ORIGINATION FORM

Proposed Revisions to a Standard Plans Index
(Please provide all information — Incomplete forms will be returned)

Index Number: 450-010
Sheet Number (s): Sheet 1 of 2
Index Title: Florida I Beam - Typical Details and Notes

Updated language concerning N type strands in the notes for clarity.

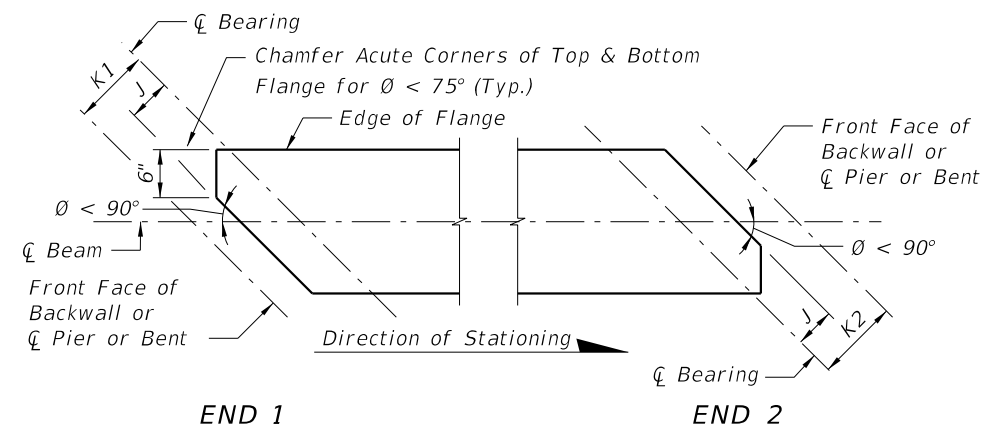
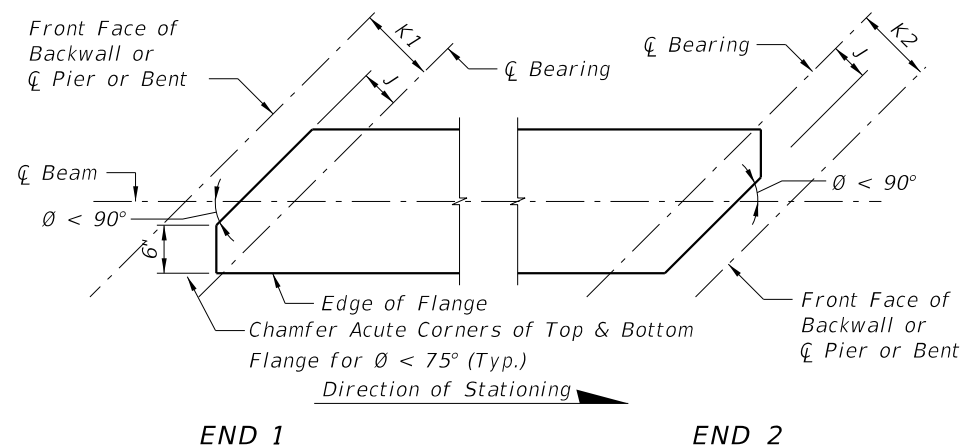
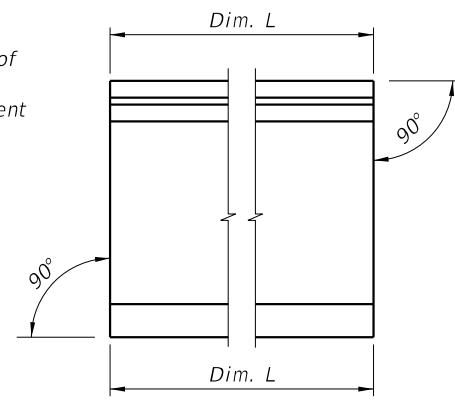
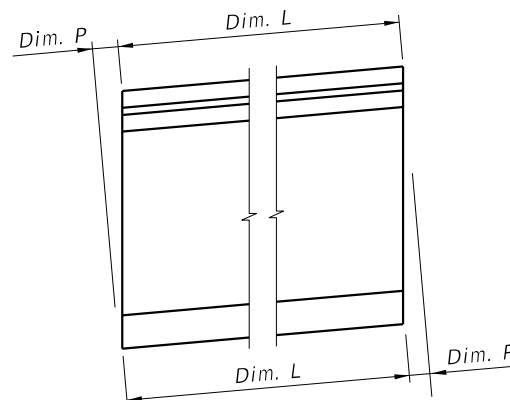
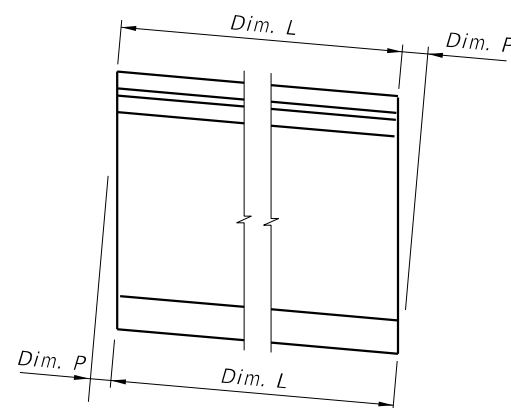
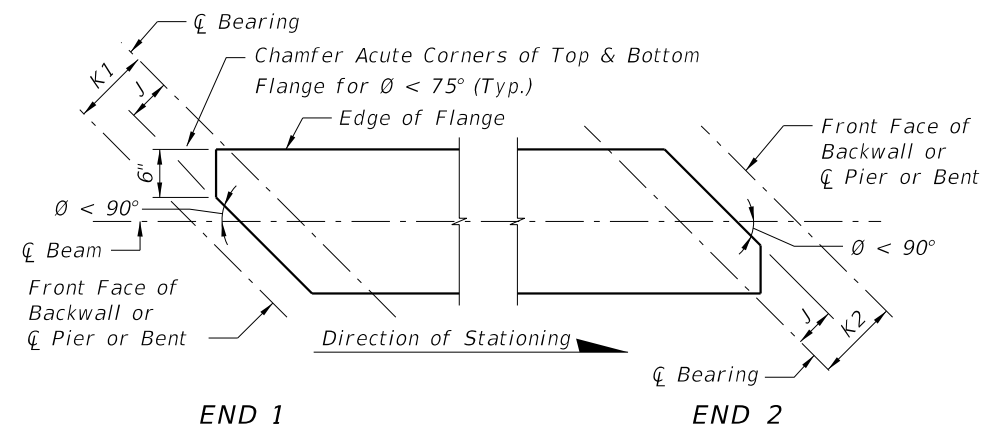
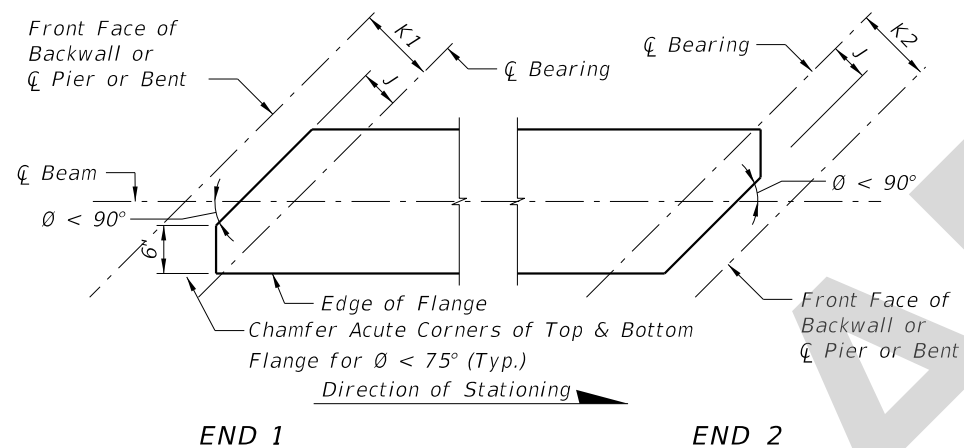
3. Concrete cover: 2 inches minimum.
4. ~~Strands N: 3/8" diameter, stressed to 10,000 lbs. each.~~ **Stress Strands N to 10 kips**
5. Place one (1) Bar 5K or 5Z at each location. Alternate the direction of the ends for each bar (see "ELEVATION AT END OF BEAM" in Standard Details).

- Concrete cover: 2 inches minimum.
- Stress Strands N to 10 kips each.
- Place one (1) Bar 5K or 5Z at each location. Alternate the direction of the ends for each bar (see "ELEVATION AT END OF BEAM" in Standard Details).
